- A. Internal Harness Solder Connection Problem - 3-Cyl. Merc 650
- B. Poor Idle Condition - Cylinder Block Bleed Restrictors
- C. Wire Rerouting to Prevent Chaffing - 1974 Merc 850
- D. Electric Start Kit Identification - Merc 200
- E. New Flush Test Device - Merc 1500-1150-850

Figure 1. Nylon Restrictor

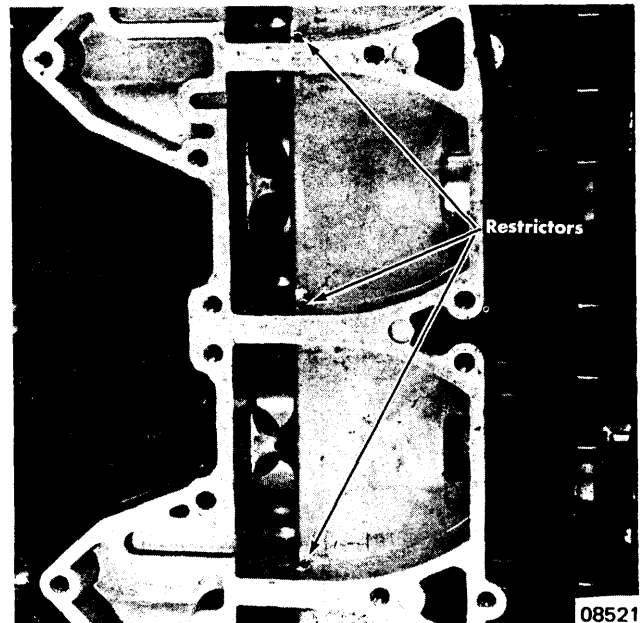
Merc 1500-1400-1350-1150-850, 800 (excluding 1969) and 650 (3-Cyl. 1972) models have a nylon restrictor in the intake passage of each cylinder, except the lower cylinder. (Figure 1) Purpose of this restrictor is to aid in the prevention of fuel puddling in the intake passage. Should a poor idle condition exist in any of the above outboards, check intake passages, as restrictors may be missing. Replace a missing restrictor with Part No. A-66517.

Figure 2. Wire Location

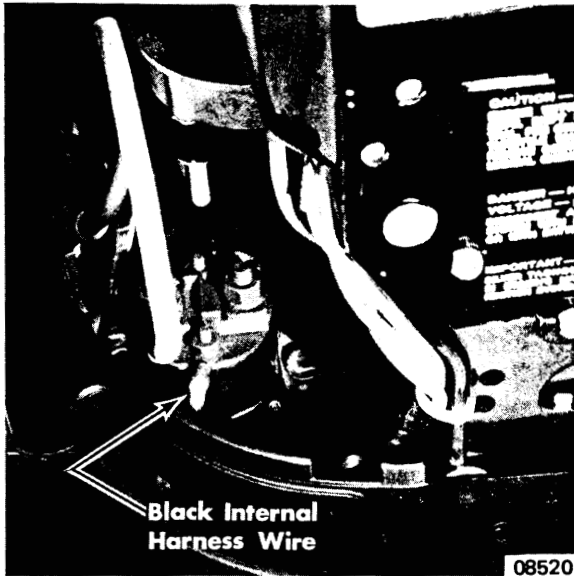
- (1) Serial No. 3866326 thru 3869010 - Small black internal harness wire to starter solenoid must be located as shown in Figure 2.

Figure 3. Wire Routing

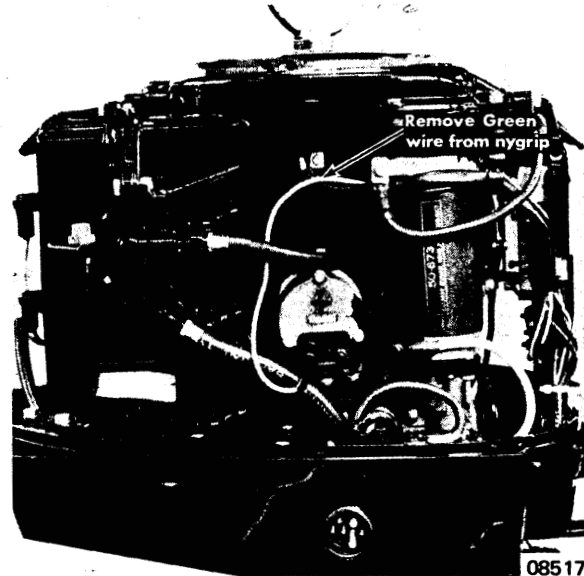
(2) Serial No. 3866325 and below - Remove green switch box to coil wire from nygrip and route as shown in Figure 3.

Figure 4. Flush Test Device

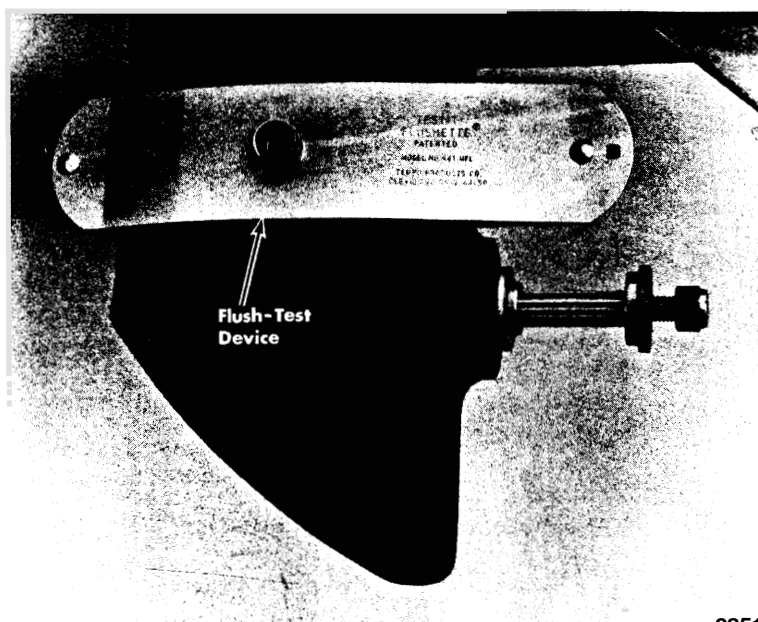
If a Merc **1500-1150-850** must be operated while flushing, it is necessary to use the new Flush Test Device (**C-67832**) which attaches directly over the intake holes in the contoured gear housing strut and provides cooling water at this point. **DO NOT OPERATE** the outboard above idle speed while flushing, or RPM cannot be controlled.
